**DA2016/017/02
22 November 2018**

27-35 PUNCHBOWL ROAD - SECTION 4.55 TRAFFIC REVIEW

SCT Consulting has been engaged to prepare a Section 4.55 Traffic Review of proposed amendments to existing development application (DA) consent 2016/17/1 at 27-35 Punchbowl Road, Belfield.

Figure 1 South western additional bays swept path assessment – Level 1

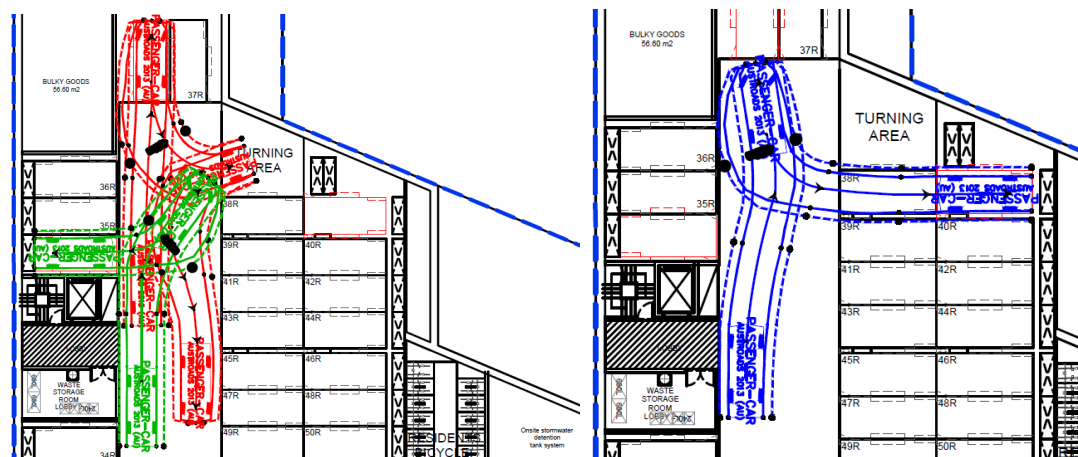
Analysis of manoeuvres to access the new parking bays adjacent to 35R, 37R and 38R in the south western section of basement level 1 (top of the drawing) are shown in **Figure 1**.

The number of turns in each manoeuvre is considered appropriate given the nature of the facility.

Figure 2 Central additional bays swept path assessment – Level 1

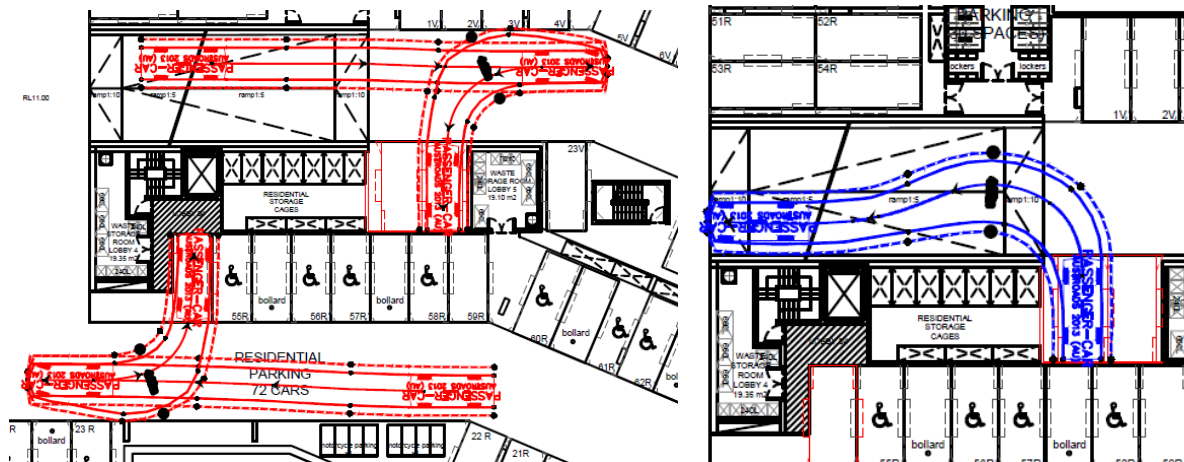
Access to the new parking bays near 23V in the centre of basement level 1 is shown in **Figure 2**.

The number of turns in each manoeuvre is considered appropriate given the nature of the facility.

Figure 3 Northern bays swept path assessment – Level 1

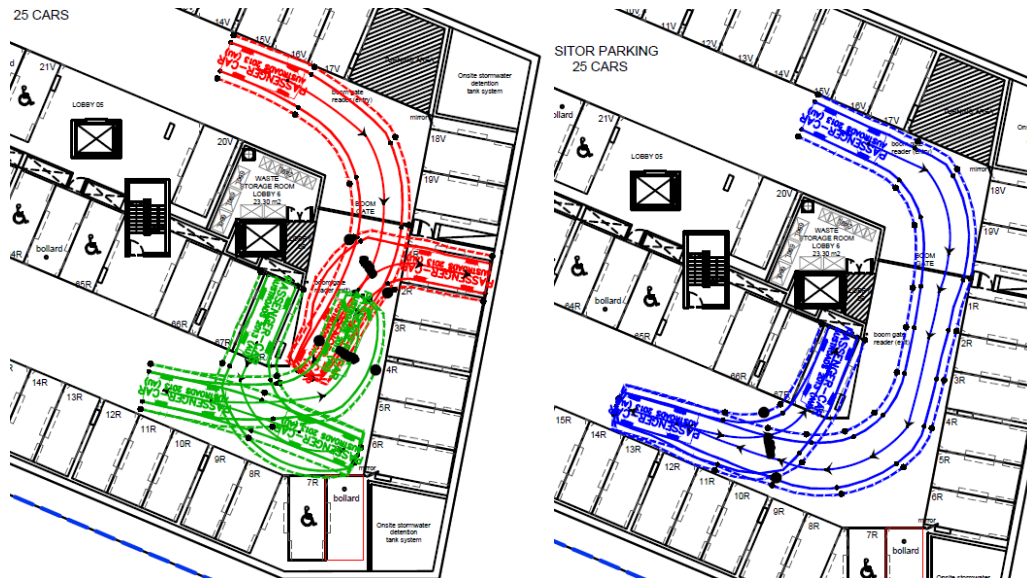
Analysis of manoeuvres to bays 1R and 68R in the northern section of basement level 1 (right of the drawing) are shown in **Figure 3**.

The number of turns in each manoeuvre is considered appropriate given the nature of the facility.

Figure 4 South western additional bays and aisle swept path assessment – Level 2

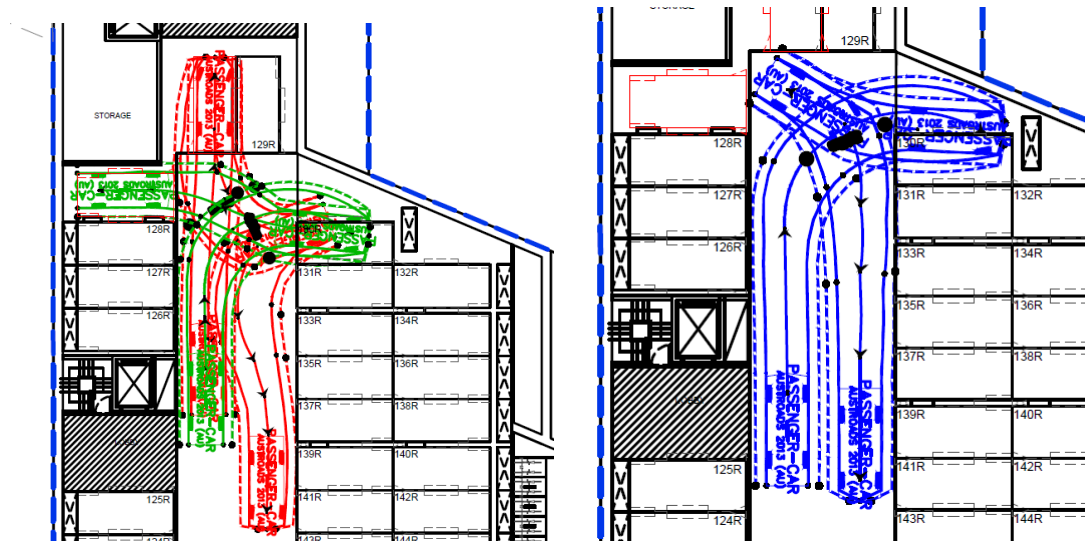
Analysis of manoeuvres to access the new parking bays adjacent to 128R, 129R in the south western section of basement level 2 (top of the drawing) are shown in **Figure 4**.

Access to the new proposed bays and turning around in the blind aisle would either impact on space 130R (if not occupied) or require an unreasonable number of manoeuvres. Removal of bay 130R to enable a turning area as per basement level 1 would address this concern. Removal of this space has been undertaken and is reflected in the current plans.

After the removal of bay 130R, the turning manoeuvres to these spaces and turning around in the blind aisle are appropriate for this type of facility.

Figure 5 South additional bays swept path assessment – Level 2

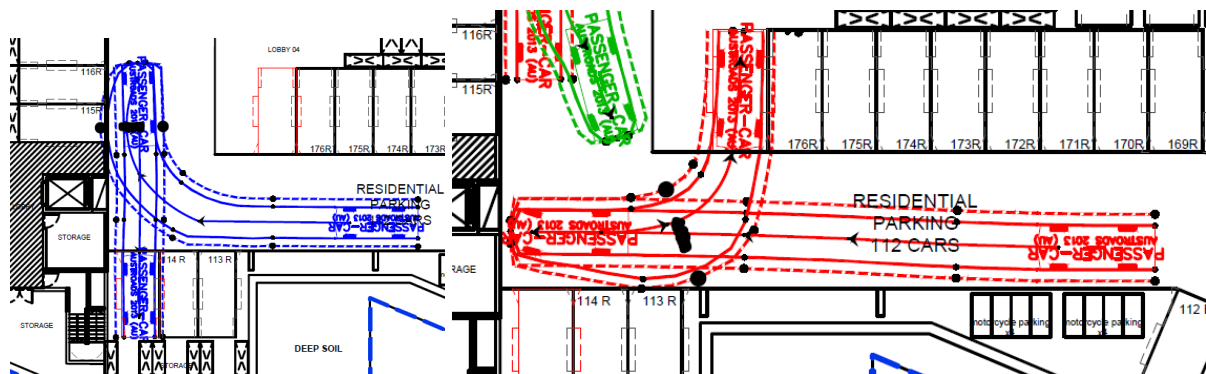
Analysis of the manoeuvre to access the new parking bays adjacent to 141R in the south section of basement level 2 (left of the drawing) is shown in **Figure 5**.

The number of turns in each manoeuvre is considered appropriate given the nature of the facility.
